SERVICE BULLETIN

Subject: Guide Assembly with Small Bore and Improper Bonded O-Ring

Service Bulletin No: 130814-001
Page 1 of 5

Figure 1, Guide Assy Showing the O-ring and Bushing Bore

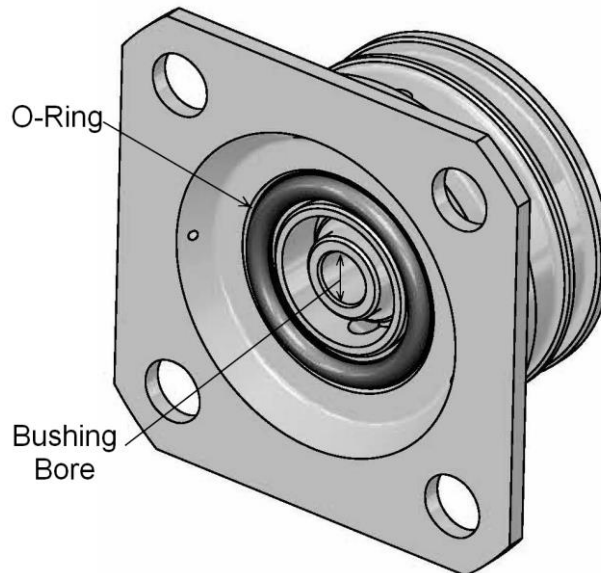
As a result of a single customer report, Wencor has confirmed that the Guide Assembly PN 3162808-6WE has a bushing bore that may be slightly undersize and the bonded in O-ring may have an inadequate bond that would allow the O-ring to come out of the groove at assembly or in service.

Figure 2, Cross-Section View of Guide Assy

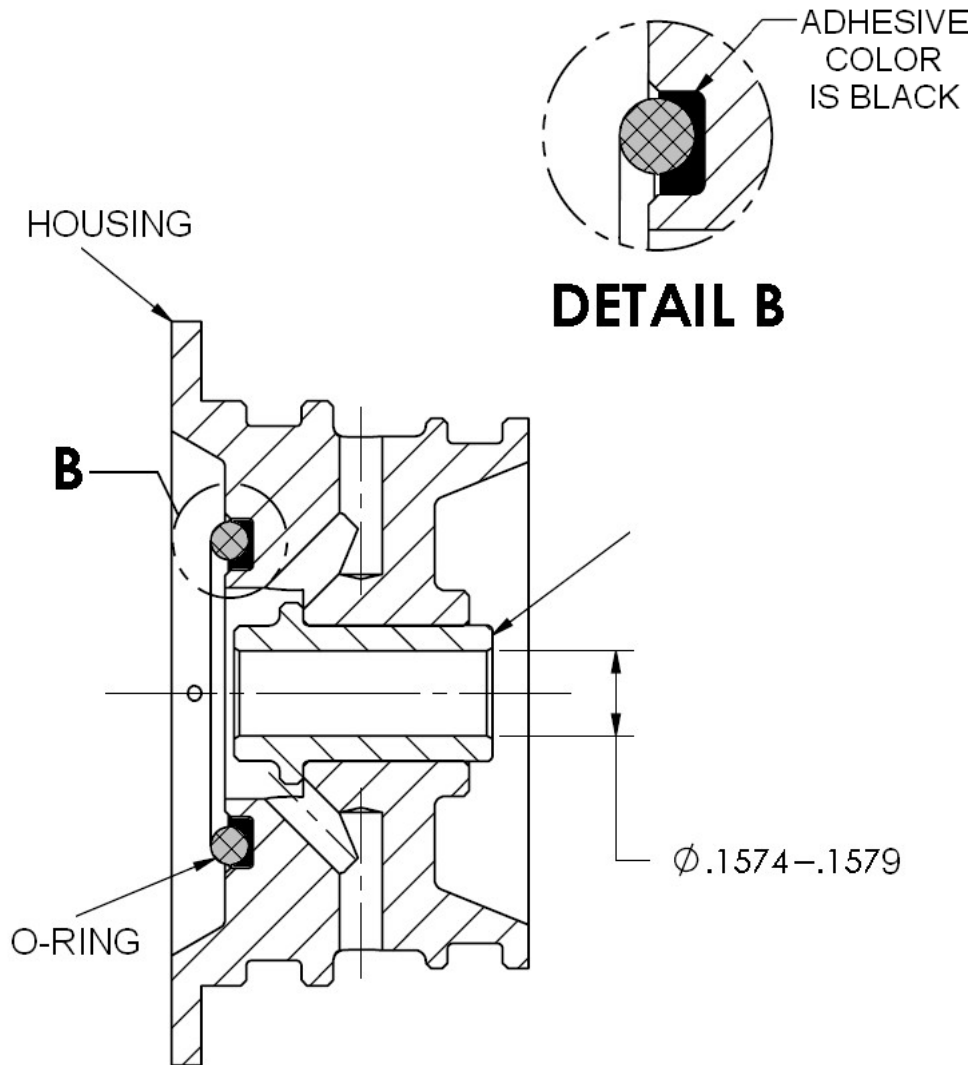
The bushing bore was manufactured with an ID size of .1570" - .1575" and the required ID size is .1574" - .1579". This allows for the possibility of an undersized condition which will prevent the guide shaft from installing into the bushing bore of the Guide Assembly.

The bonding process to bond the O-ring in the groove of the Guide Assembly may not have been done properly to achieve an acceptable bonded joint. This could possibly allow the O-ring to fall out or be dislodged from the groove.

- I. Verify the bushing bore ID is sized at 0.1574" – 0.1579" as shown in Figure 2. If the bushing bore ID size is within these limits the Guide Assembly is acceptable. If the bushing bore ID size is outside these limits, the Guide Assembly should be returned to Wencor as described in section 4 of this SB.

- II. Verify the bonded O-ring is properly bonded to the Guide Assembly. Using light finger pressure, verify all bonded surfaces of the O-ring are intact (no gaps) and the O-ring will remain in the groove. The adhesive should be visibly present on the ID and OD of the O-ring as shown in Figure 2 with enough adhesive to achieve this requirement. If the O-ring is found to be fully bonded to the Guide Assembly, the bond is acceptable. If the O-ring bond does not meet this criteria, the Guide Assembly should be returned to Wencor as described in section 4 of this SB.

Figure 3, Guide Assembly Installed Into High Stage Pilot

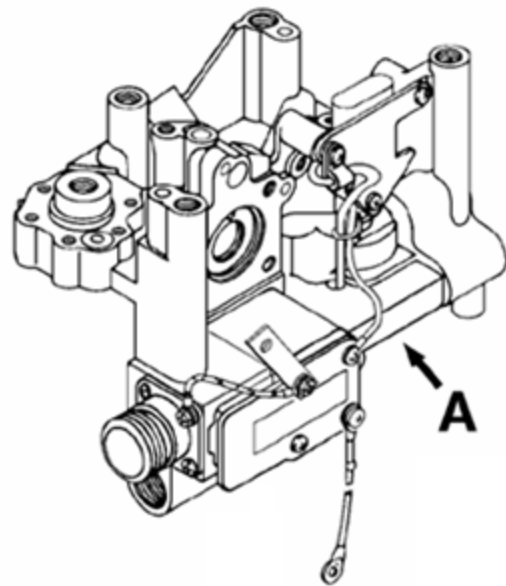
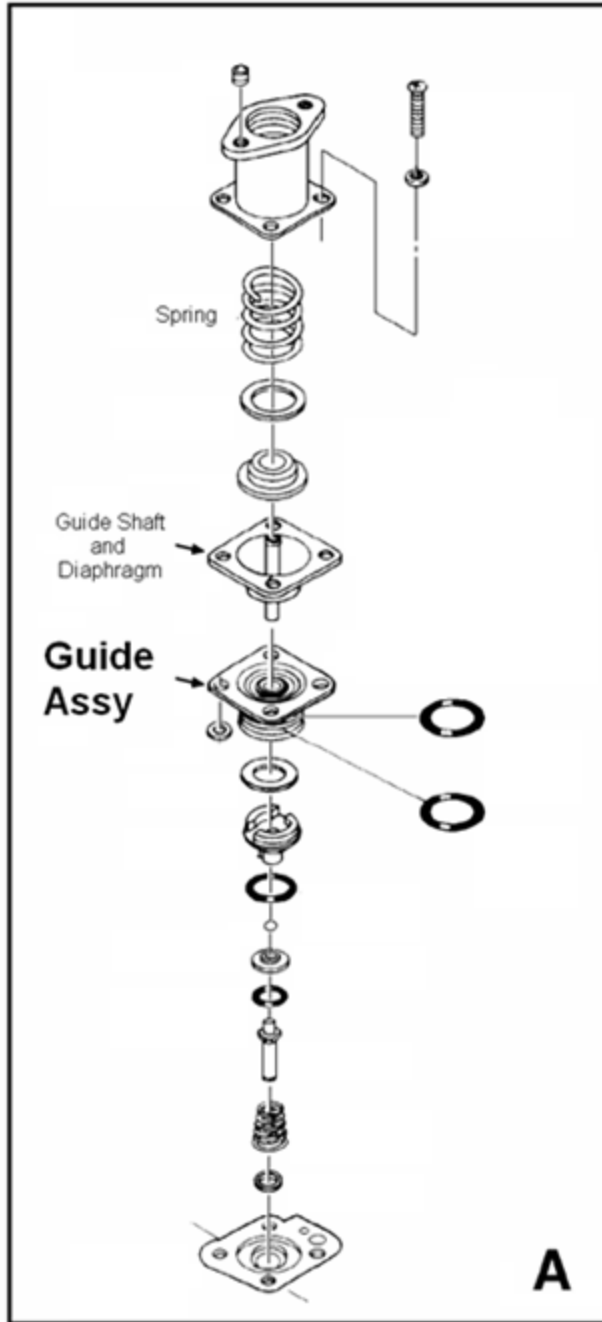
The Guide Assembly is installed in the over-pressure sensor sub-assembly of the NHA High Stage Pilot as shown in Figure 3. The Guide Assembly serves two main purposes: (a) provide a bore to "guide" the guide shaft as it moves in and out through the Guide Assembly bushing and (b) provide a seal to prevent bleed air leakage when the plate on the guide shaft contacts the bonded in-place O-ring.

All Wencor Guide Assemblies that are installed into the NHA High Stage Pilot and have passed the CMM testing requirements may remain in service at the discretion of the operator and in accordance with the B757 AMM.
